工程指示 / 要求簡箋(E.I.)

工程指示編號：EI/ 9496 /18

工程名稱：日出康城7期(平台)

工程項目：WW4(A-N)地盤用鐵件修改

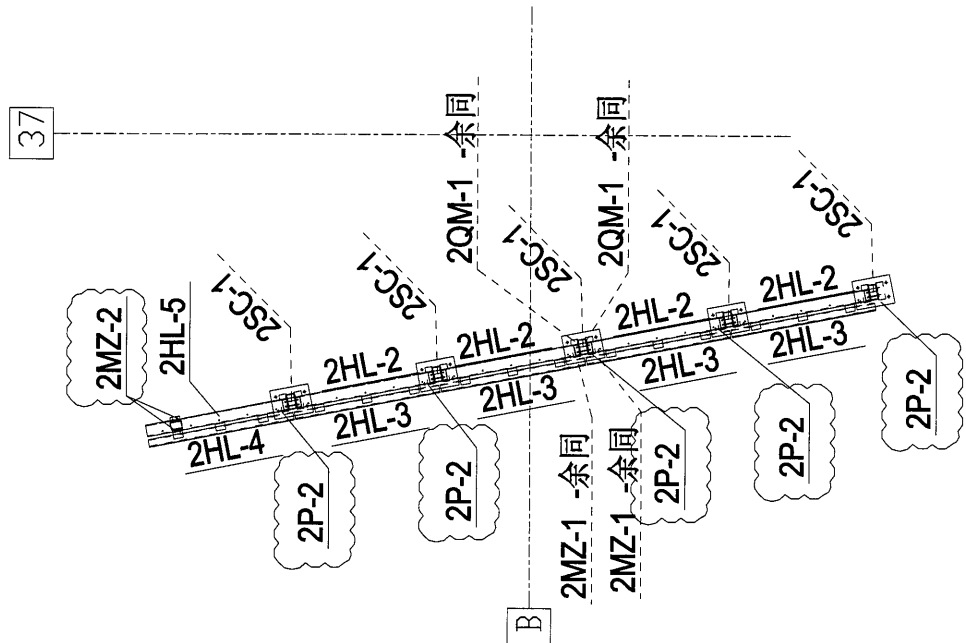
- 1, 2HL-6取消。
- 2, 新增5件2P-2。
- 3, 新增2件2MZ-2。

PART PLAN OF WINDOW-WALL (WW4)

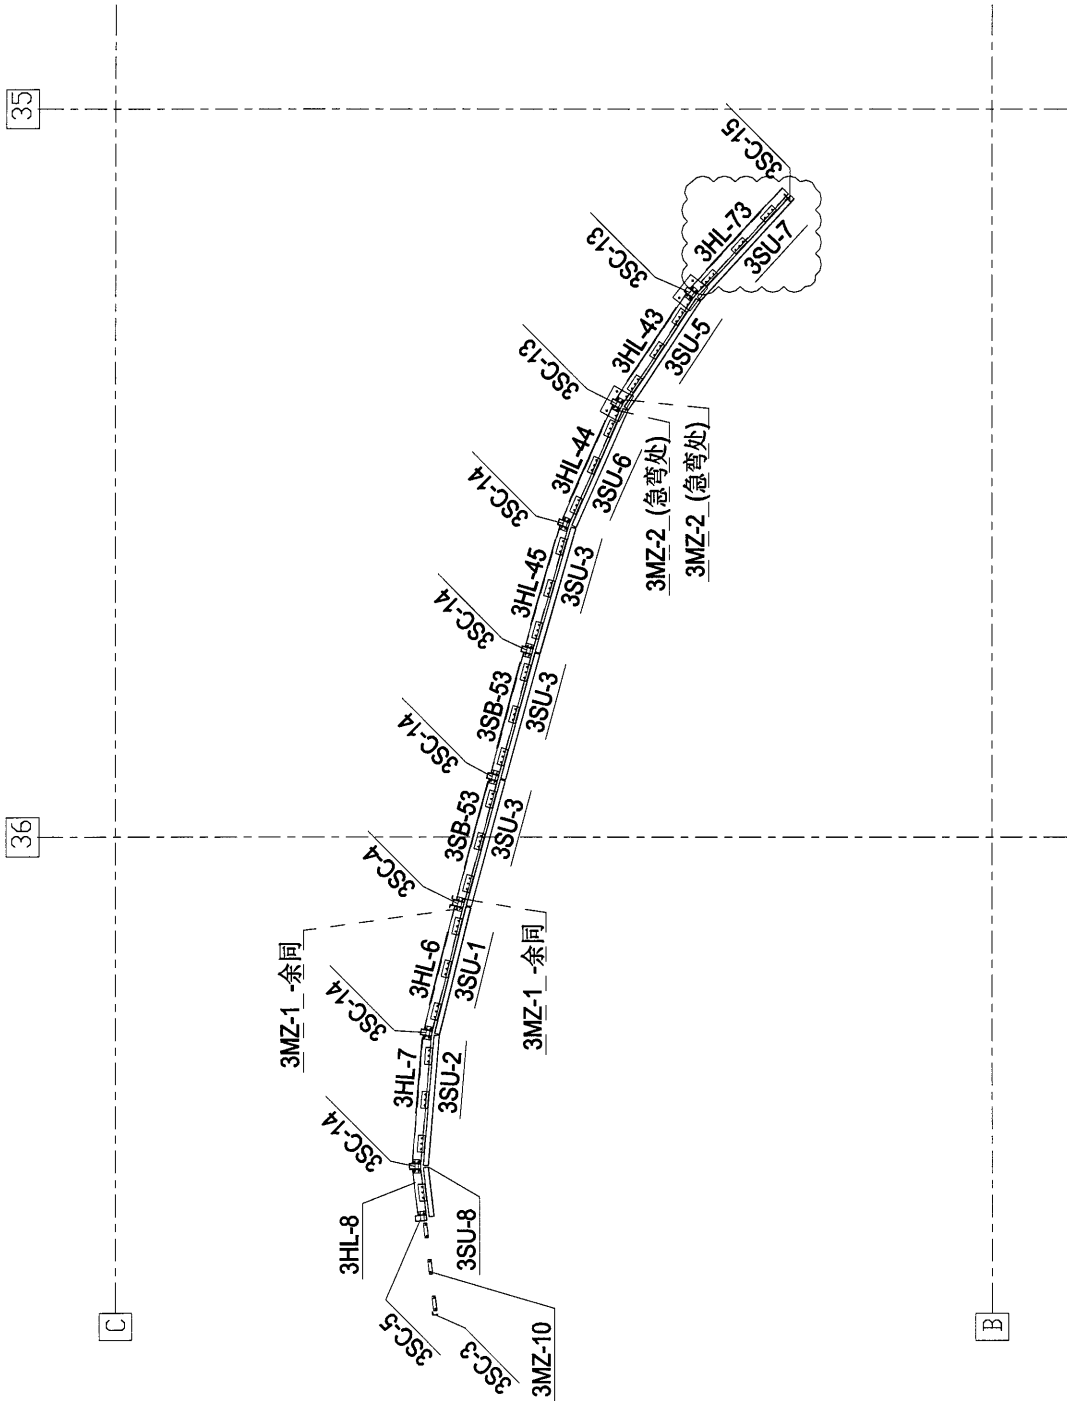
1, 3HL-73,3SU-7预长100。

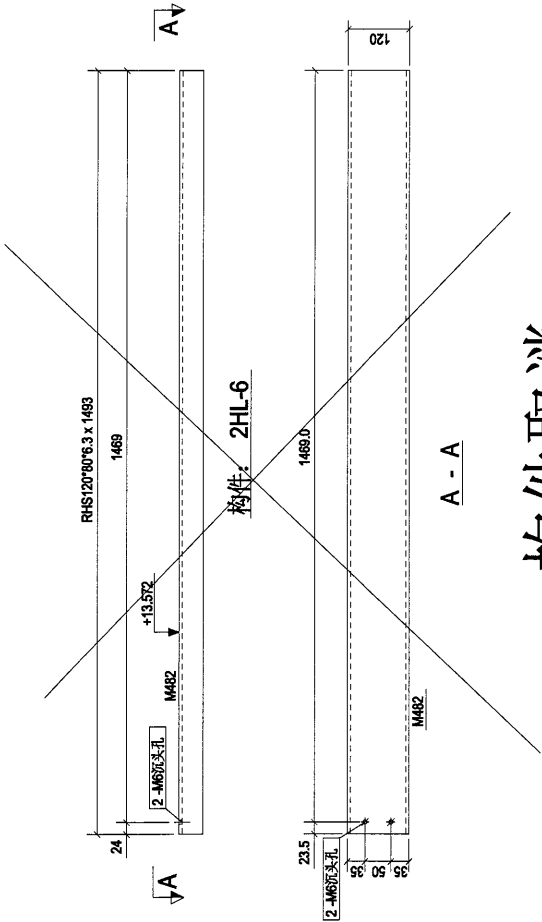
构件取消

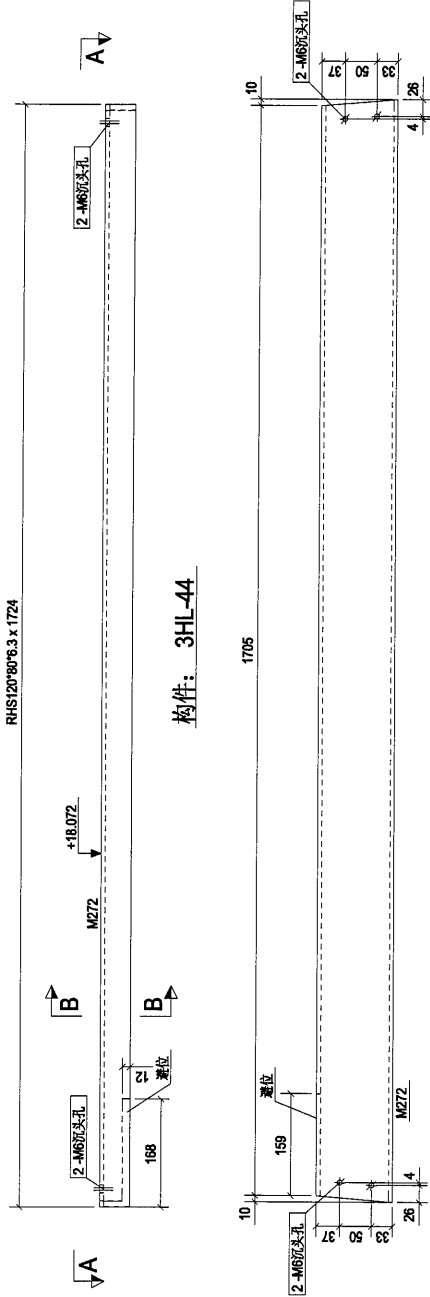
修改说明:
1, 去牙孔, 开避位。

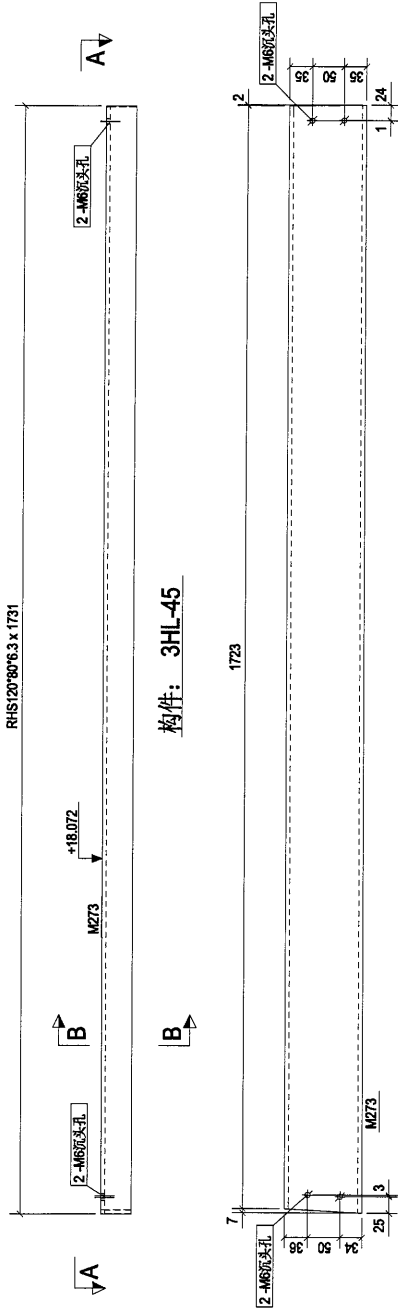
修改说明:
1, 去牙孔.

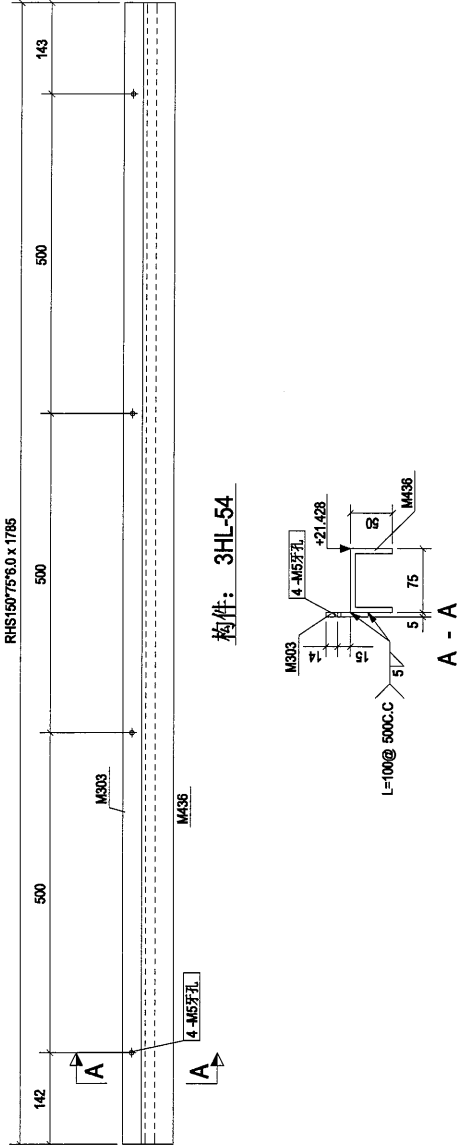
修改说明:
1, 数量减+1.

构件: 3HL-69

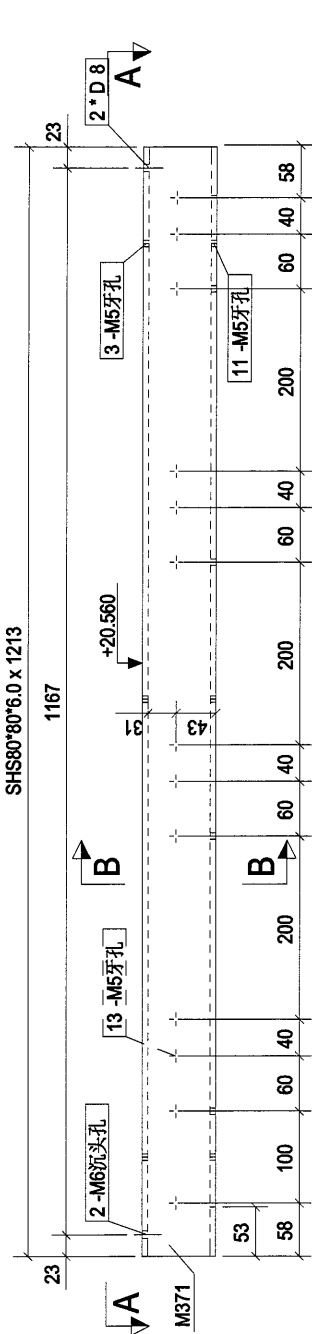
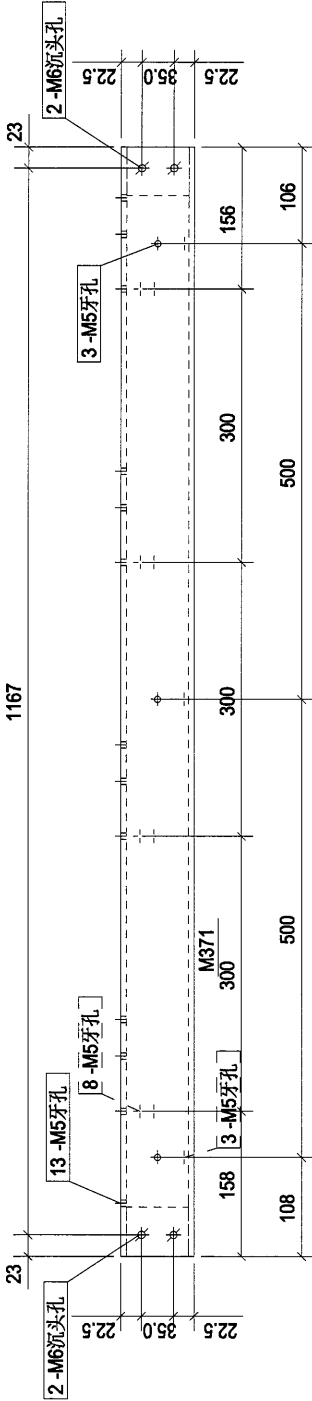
修改说明:
1, 取消M340, 增加M5牙孔和M6觉头孔。

构件: 3HL-71

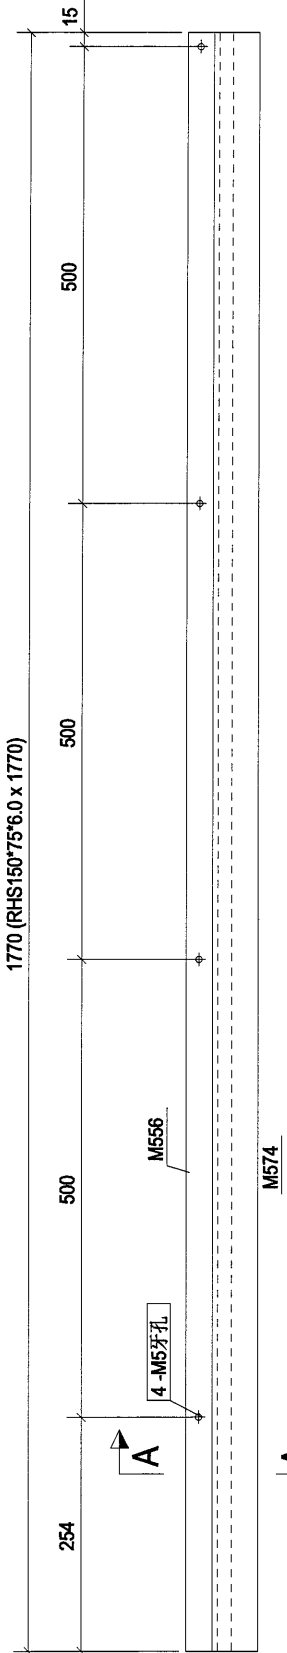
修改说明：
1，杆件加长100（做地盘预留）。

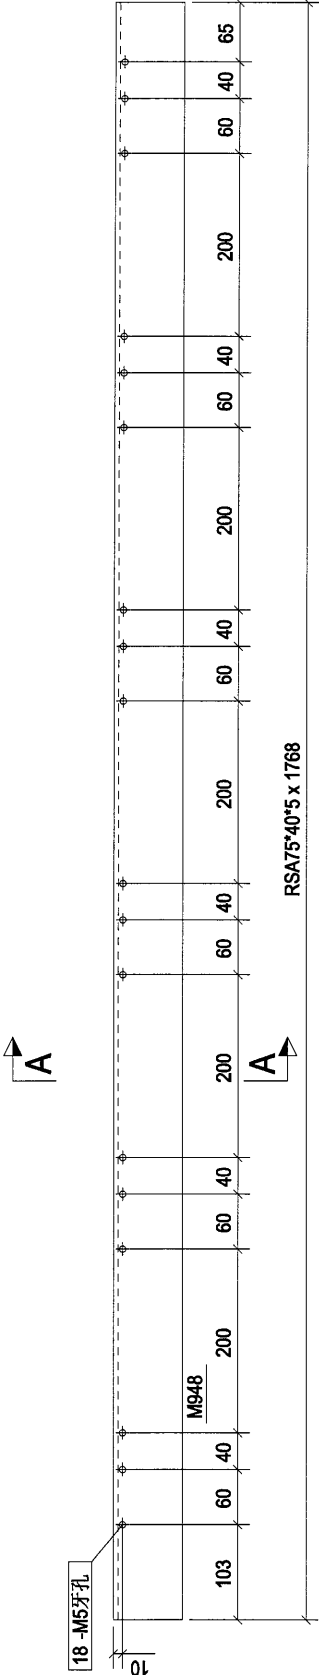
修改说明:
1, 角码做散件(3SJ-7)出货。

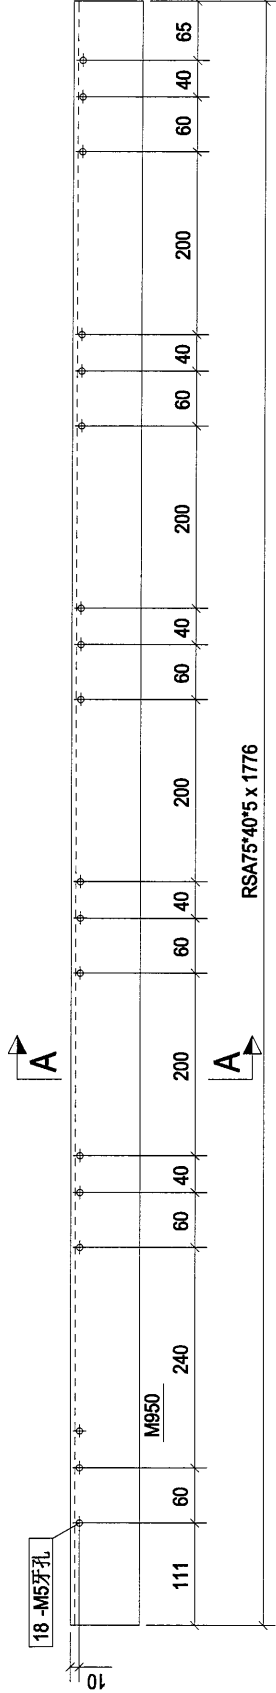
修改说明:
1, 角码做散件(3SJ-7)出货。

RHS150*75*6.0 x 1782

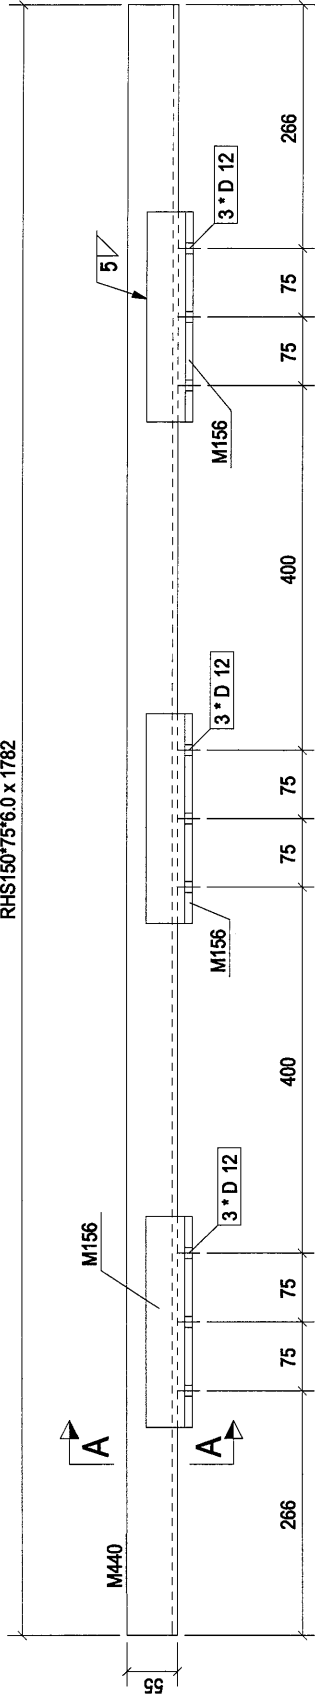
修改说明:
1, 角码移位。

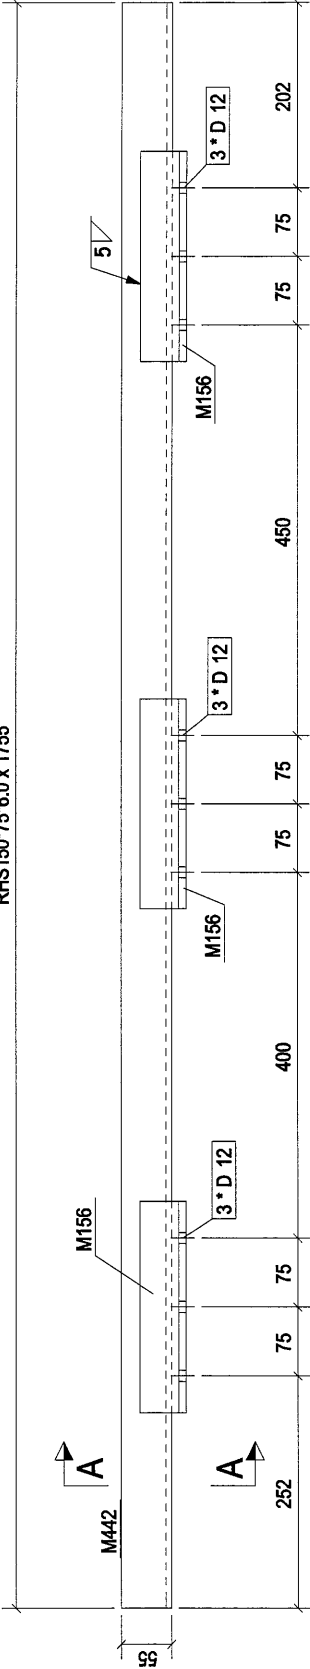
修改说明:
1, 角码移位。

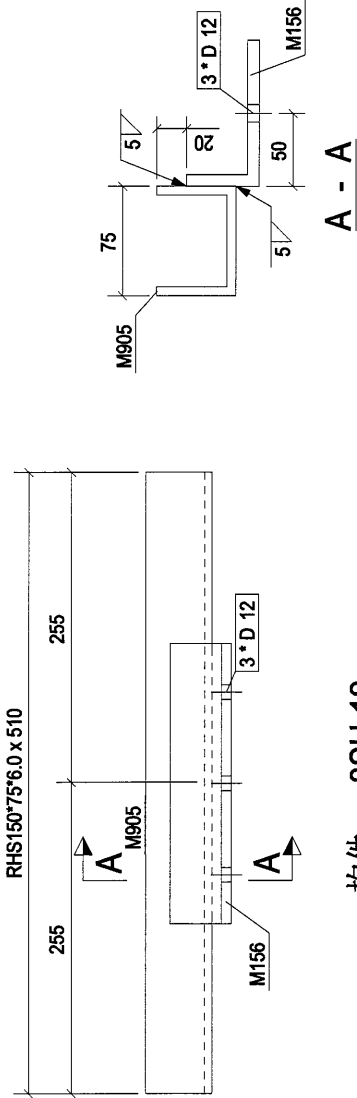
修改说明:
1, 补回角码, 取消加孔。
